**Ibis Landing a/k/a Copperhead f/k/a Classic Hills MPD
Administrative Amendment to Planned Development
Schedule of Deviations and Justifications
ADD2024-00046 – Revised June 2024**

Minor updates to existing deviations to reflect changes in code as noted by strike-through underline. ADD2024-00046 rennumbers deviations to reflect withdrawn deviations and previously approved ADD2006-00187 deviation as noted below.

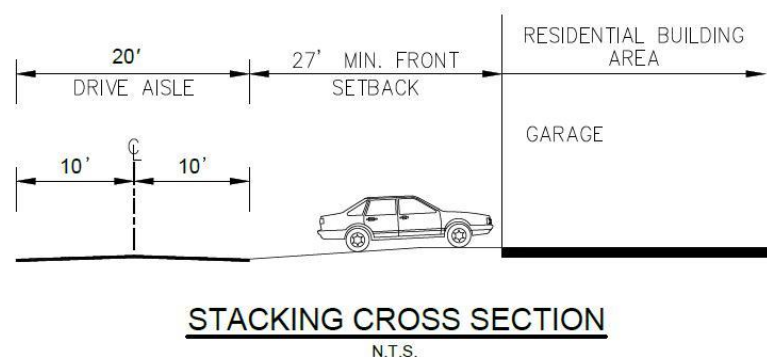
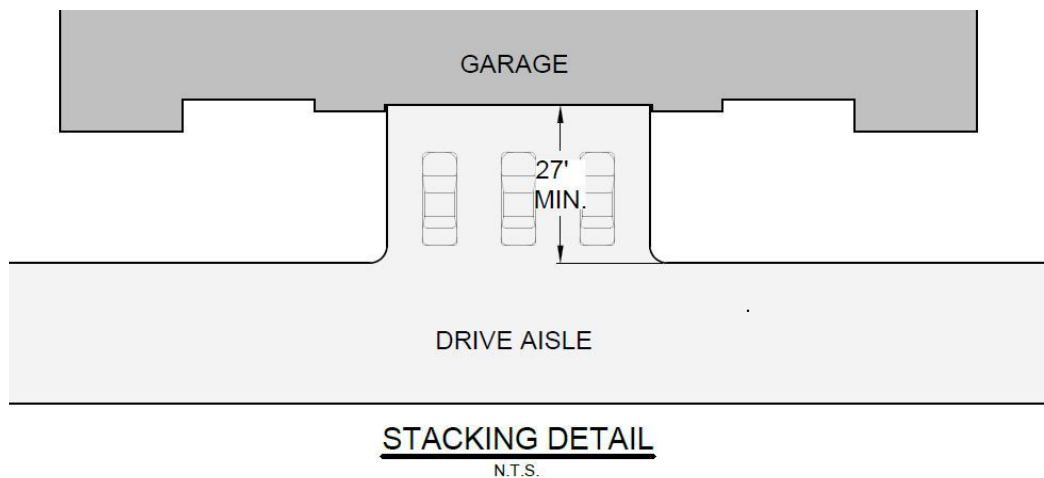
Deviation (9): seeks relief from LDC Section 10-296(k) which requires dead-end streets to provide a circular turnaround, as show in 10-714(b); to allow T-turnarounds where shown on the MCP.

Justification: The requested deviation is included in LDC Section 10-104(a)(9) list of provisions where the Development Services Director is authorized to grant administrative deviations. This deviation is requested to allow T-turnarounds less than 150' in length in the areas identified on the MCP. These short joint driveway configurations do not require a turn-around per NFPA standards. These short joint driveways only serve four units each side for a total of eight units and should not be held to the dimensional requirements for a roadway. These joint driveways provide adequate access to the units. The intent of this regulation to protect the health, safety and welfare of the public will be served and the planned development will be enhanced by approval of this deviation. Please see attached letter of no objection from Lehigh Acres Fire Control and Rescue District. The request is also consistent with the applicable criteria for administrative deviations contained in LDC Section 10-104(b): (1) The alternative proposed to the standards contained herein is based on sound engineering practices (2) The alternative is no less consistent with the health, safety and welfare of abutting landowners and the general public than the standard from which the deviation is being requested; (3) not applicable; (4) The granting of the deviation is not inconsistent with any specific policy directive of the Board of County Commissioners, any other ordinance or any Lee Plan provision; and (5) not applicable; and (6) not applicable.
